# Urban Design Peer Review

## Western Sydney University - Bankstown Campus Proposal

Prepared for City of Bankstown Canterbury

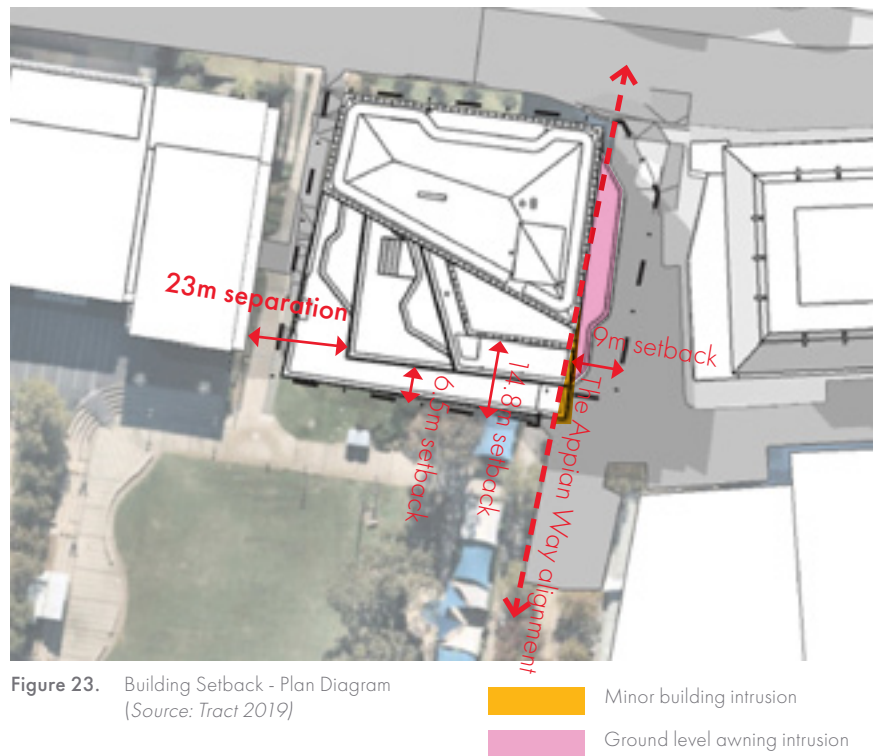
- A 9m setback to the eastern boundary with a minor building intrusion into The Appian Way alignment. There is some complexity to the eastern interfaces as the land title extends into The Appian Way as illustrated in Figure 23. However, the proposal generally maintains a clear and open view along The Appian Way - Addresses Design Principle DP02.
- The upper portion of the proposed tower is rotated and setback approximately 6.5m-14.8m on the southern side. The proposal's stepping form at Levels 3 & 7-13, which reduces the bulk facing the Park, provides a relatively slender profile. (These setbacks also assist with the minimisation of overshadowing to the public domain, as outlined in Section 5.0 of this report) - Addresses Design Principles DP03, DP-AD01.

***The proposed setbacks up to Level 13 provide visual articulation and relief for the built form when viewed at street level and also on key view lines within the city centre, and as such are considered appropriate.***

***However, the articulation and building setbacks above this to Levels 14-18 present challenges to both overshadowing and visual bulk and can be supported with amendments (outlined in "Design Implications" on page 49 of this report).***

Figure 30. PKP Shadow Diagram Winter Solstice [10am-12pm, 21st June] (Source: Tract 2019)

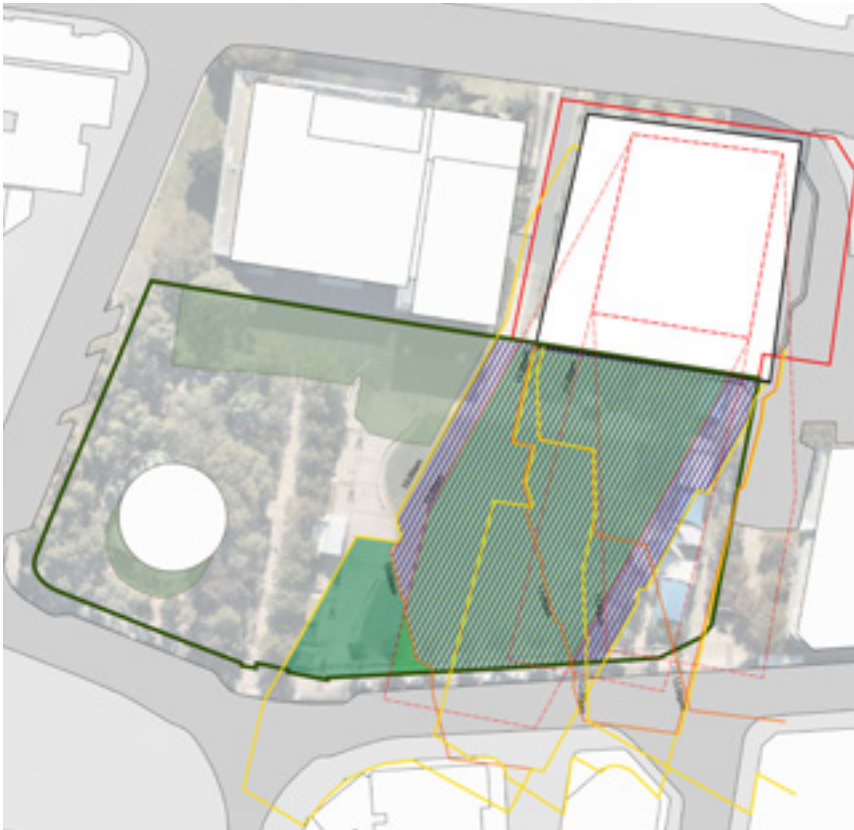
- All three scenarios achieve at least **3 hours** direct sunlight to more than **50%** of the **total** Park area, between **10am - 2pm** on Winter Solstice.
- Compared with Scenario 2 and 3, Scenario 1 achieves one more hour direct sunlight to more than 50% of the total Park area at 10am due to its reduced building height and bulk.

Figure 33. The Appian Way Shadow Diagram Winter Solstice [12pm-4pm, 21st June]  
(Source: Tract 2019)

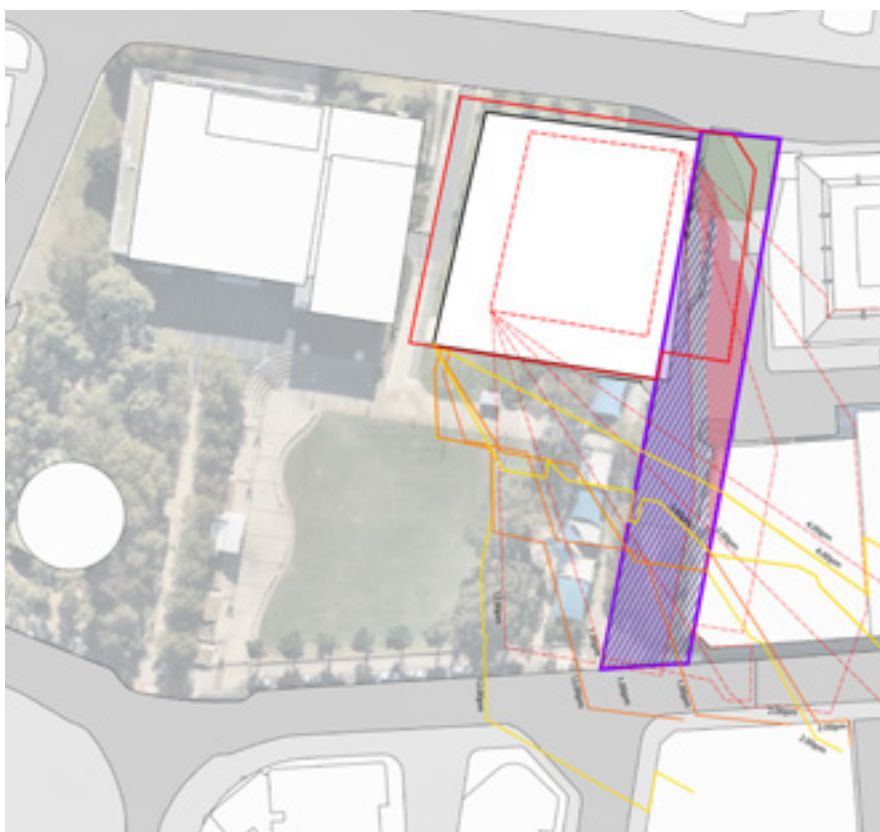
Between 12pm - 4pm, all three scenarios achieve direct sunlight to approximately 50% of The Appian Way. All three scenarios provide good solar access to more than 70% of the retail facade at the southern end of The Appian Way.

Figure 35. The Appian Way Shadow Diagram Equinox [12pm-4pm, 22nd September]  
 (Source: Tract 2019)

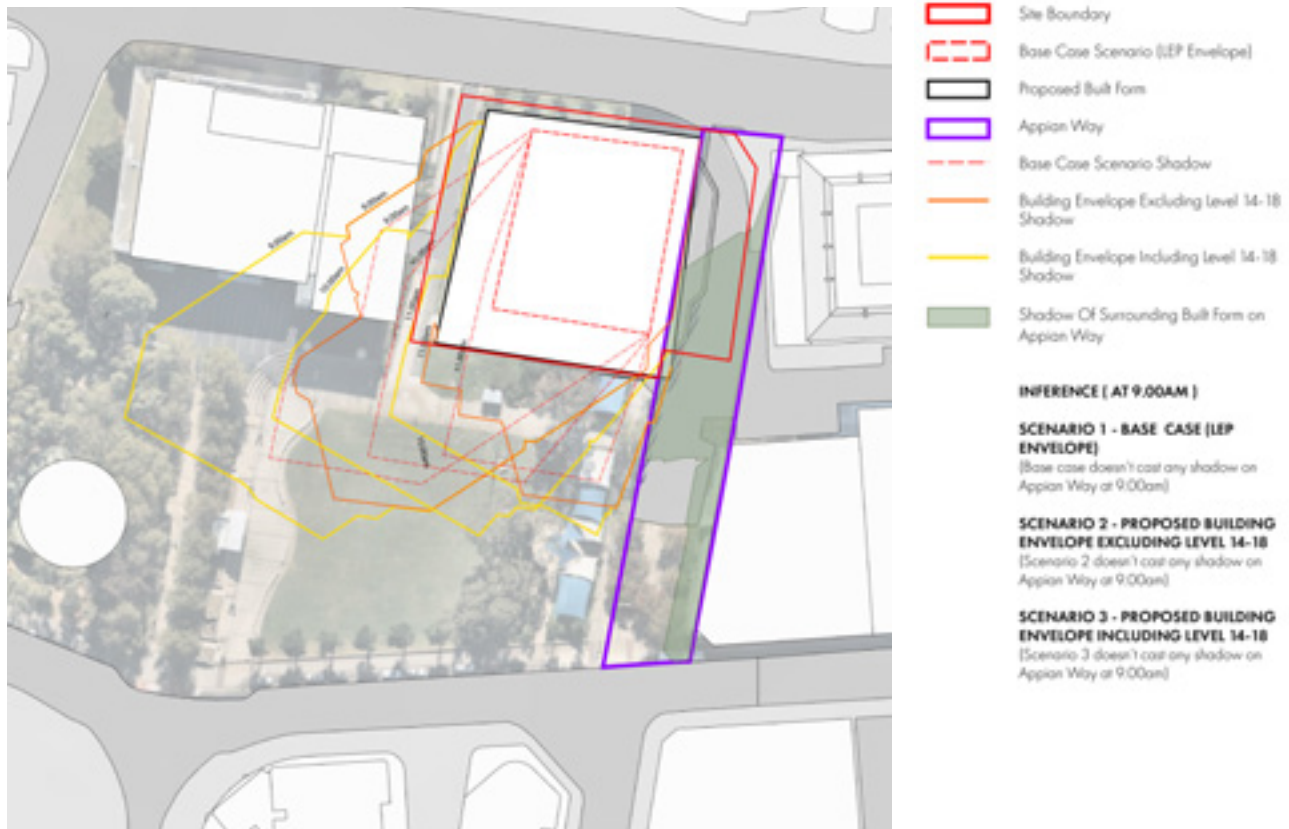
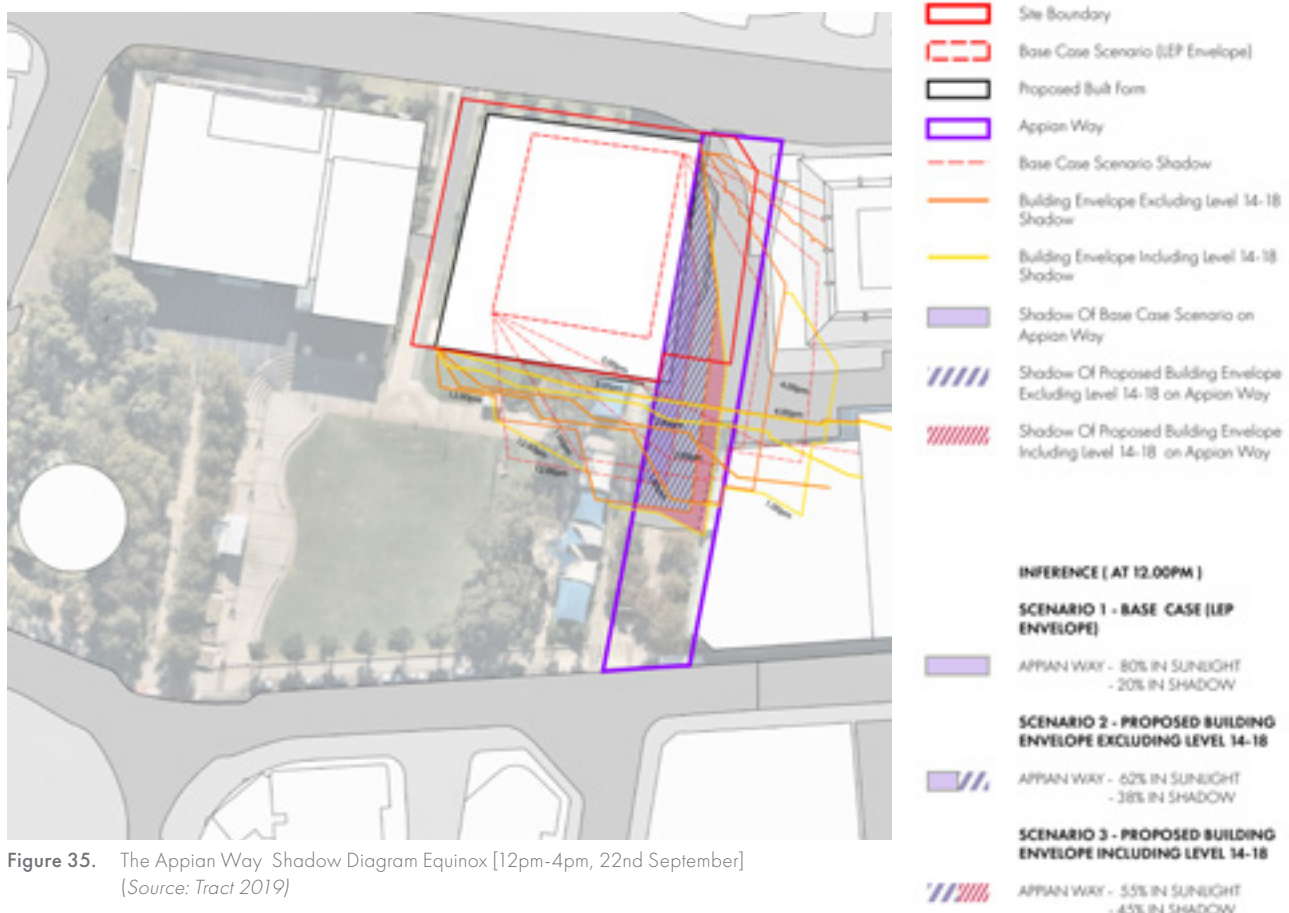
- All three scenarios provide better outcomes of the solar access to The Appian Way on Equinox than on Winter Solstice.
- All three scenarios achieve 5 hours of direct sunlight to more than half of the retail facade, and at least 3 hours of direct sunlight to more than 50% of The Appian Way between 9am-4pm on Equinox.

- The Appian Way is defined as a key 'activity spine' with future characters of eat street, street life, retail and nighttime activities. Most activities tend to happen in mid to late afternoon. Therefore overshadowing to The Appian Way becomes less of a concern in comparison with the Paul Keating Park.
- All three scenarios provide better outcomes of the solar access to The Appian Way on Equinox than on Winter Solstice.
- All three scenarios achieve 5 hours of direct sunlight to more than half of the retail facade, and at least 3 hours of direct sunlight to more than 50% of The Appian Way between 9am-4pm on Equinox.

**Figure 36.** View 1 north from The Appian Way  
(Source: Tract 2019)

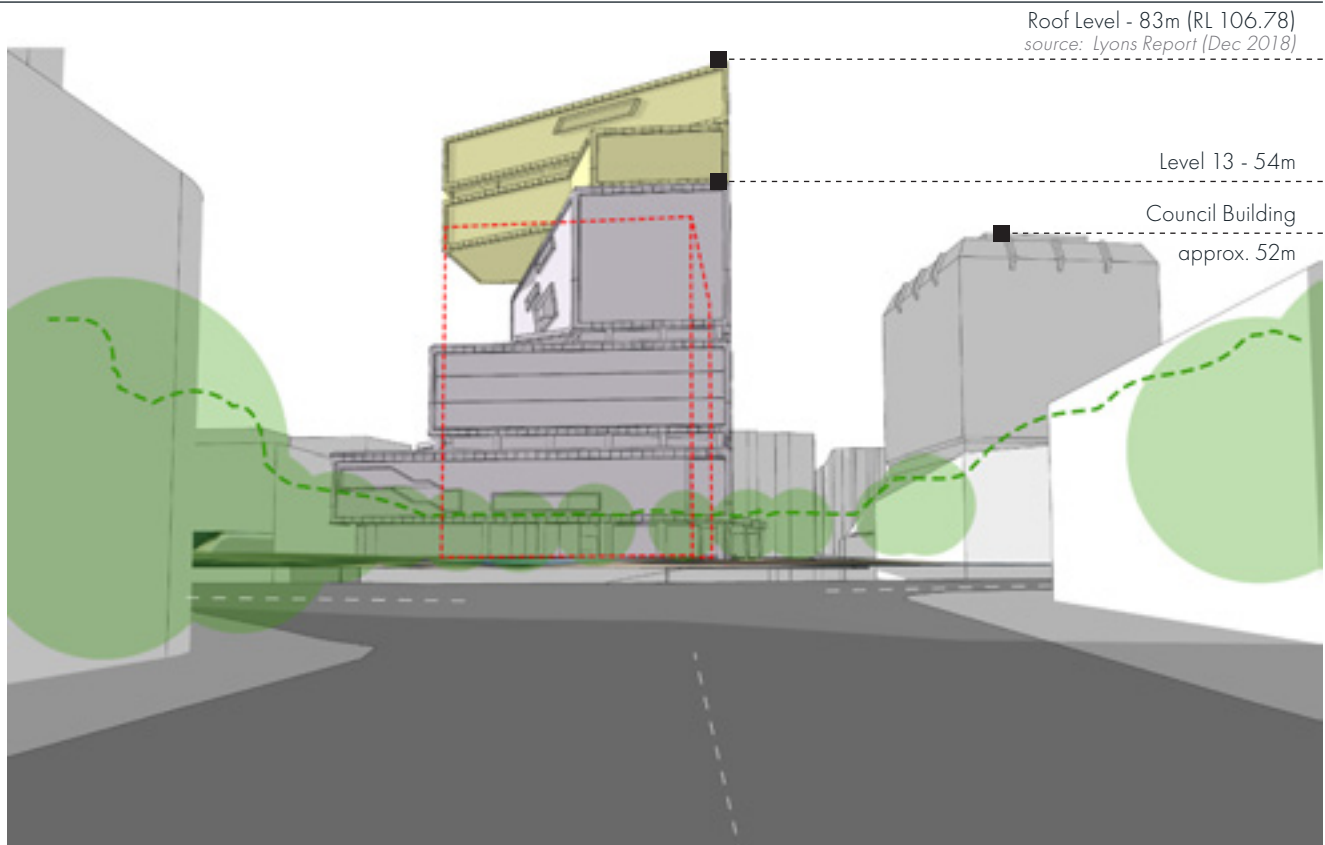
The visual bulk of the upper levels are accentuated by the cantilevered top section, and reduction of this impact should be considered.

**Figure 38.** View 3 east along Rickard Road  
(Source: Tract 2019)

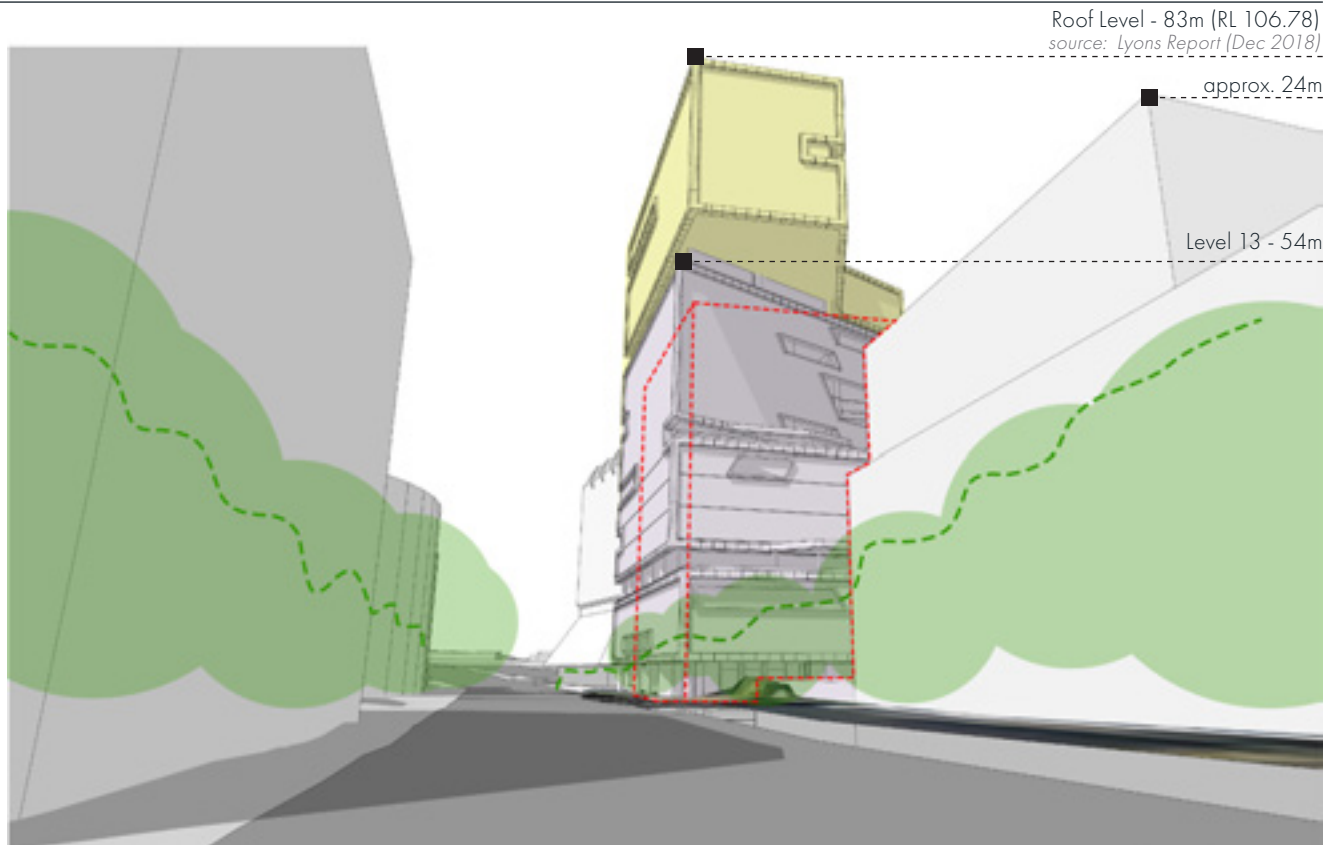
View 3 along Rickard Road presents a comparatively slender visual profile, due to the orientation of Levels 14-18 from this perspective.

Figure 40. Design Alternative from The Appian Way (Source: Tract 2019)

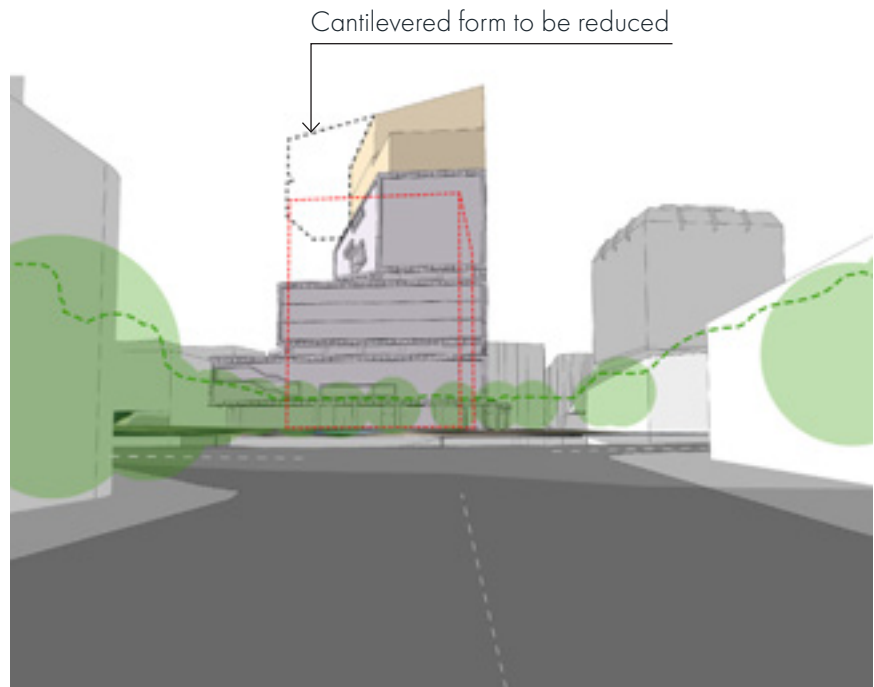
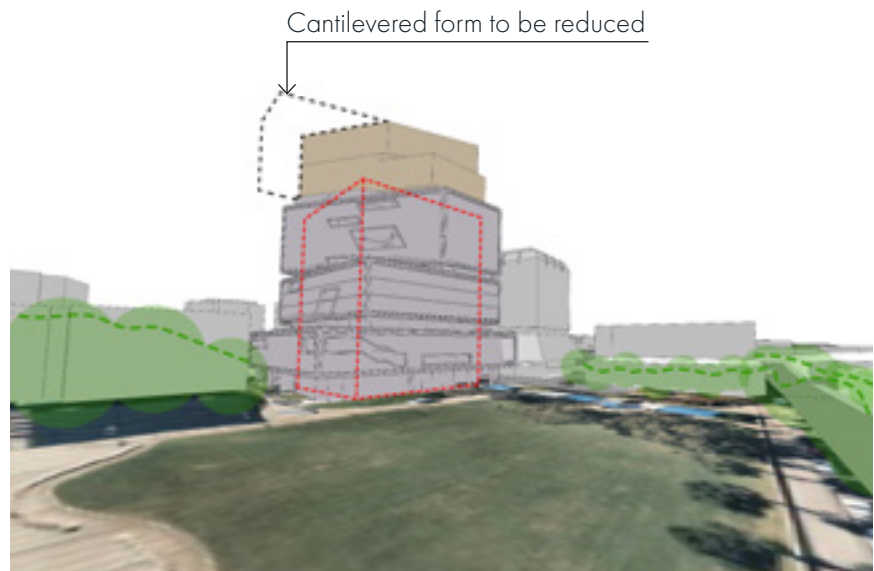
Without undertaking a comprehensive architectural planning review, the GFA/FSR advised will be estimated and indicative.

By approximate measurement, the Gross Building Area (GBA) of the removed top section is 450sqm per level. The total GBA of 5 levels (Levels 14-18) is 2,250sqm. Based on the rule of thumb for architectural design, if we assume the GFA (commercial) = 85% of GBA, then the reduced GFA is approx. 1,900sqm. The total GFA will be reduced from 29,266sqm to 27,366sqm. The FSR is consequentially reduced to 7.4:1.

These overall refinements are high-level and subject to design detail and investigation, and are provided to give further urban design direction for the Proposal.

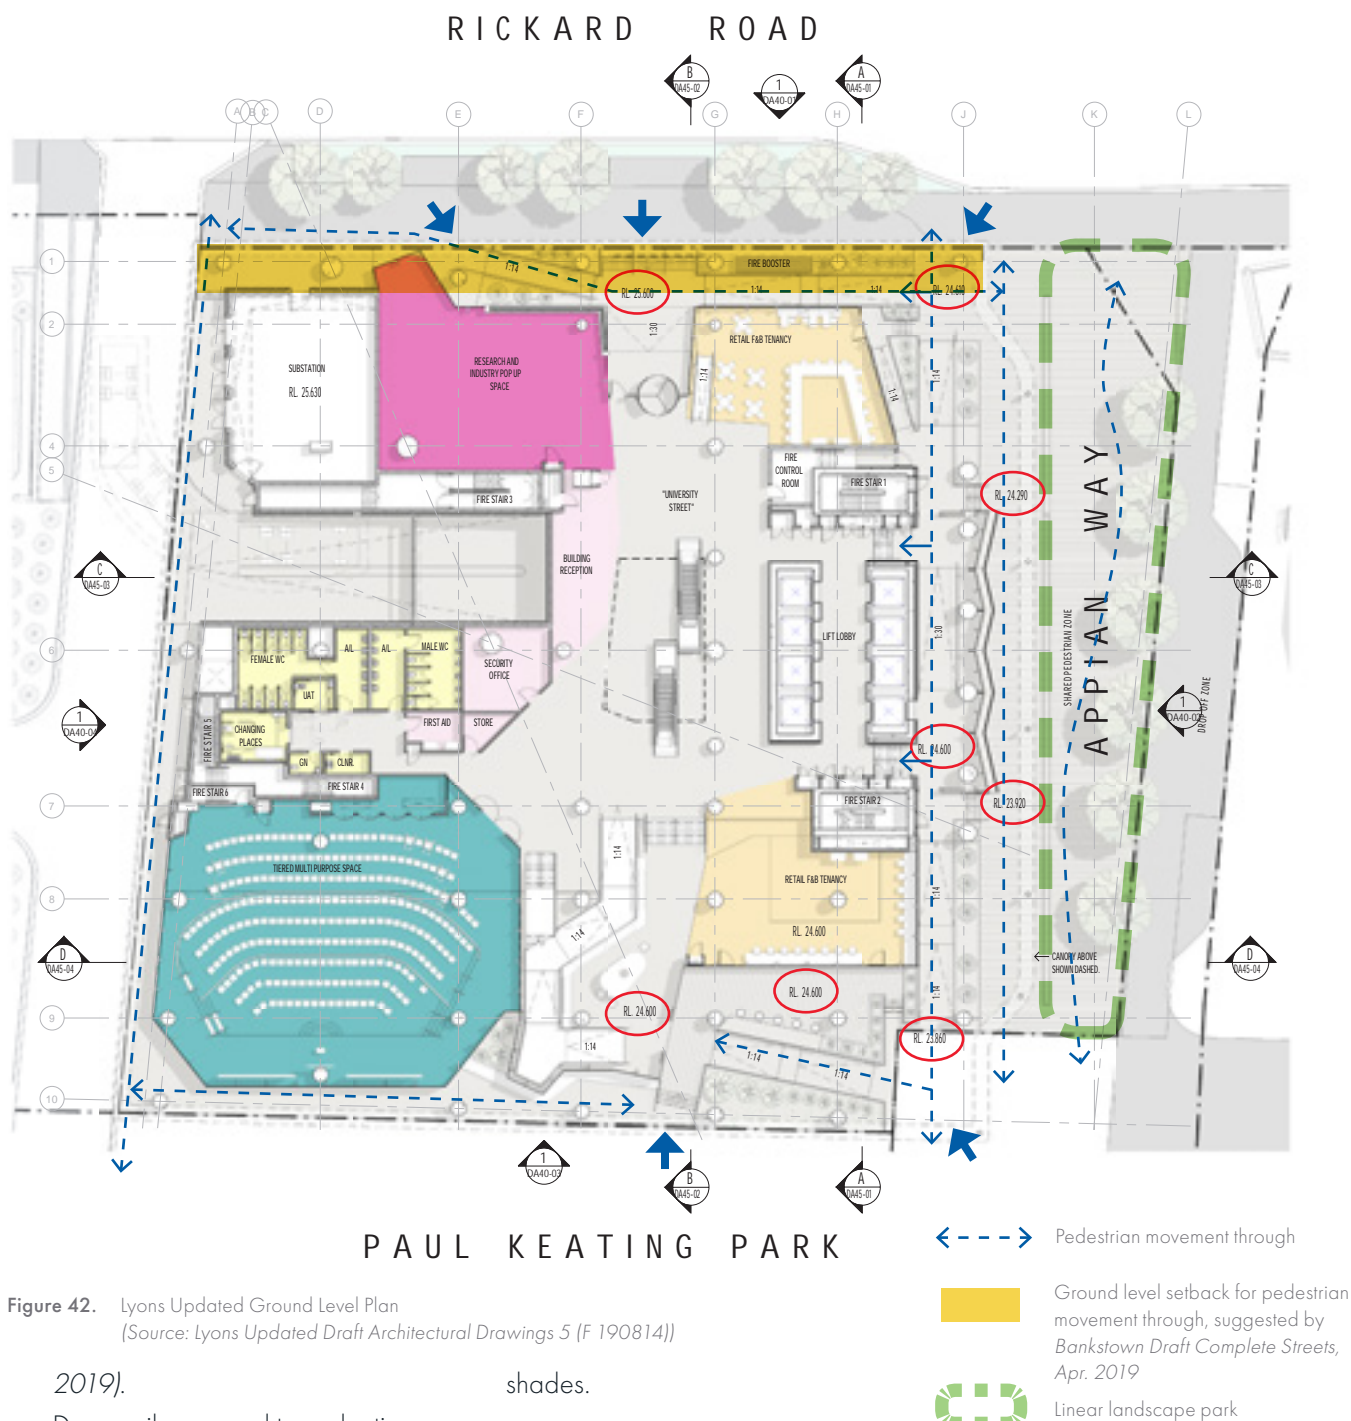
- A linear landscape park is proposed along The Appian Way frontage, which is dedicated as a shared pedestrian zone to promote pedestrian priority.
- However, the existing vehicle circulation from neighbouring properties plus the proposed pick-up/drop-off traffic at the northern end of The Appian Way may cause interruptions to pedestrian movements.

- Feature paving which defines different function zones between walking, staying and slow speed driving, are applied to The Appian Way. It helps to raise people's awareness of the speed control and pedestrian movement zones.
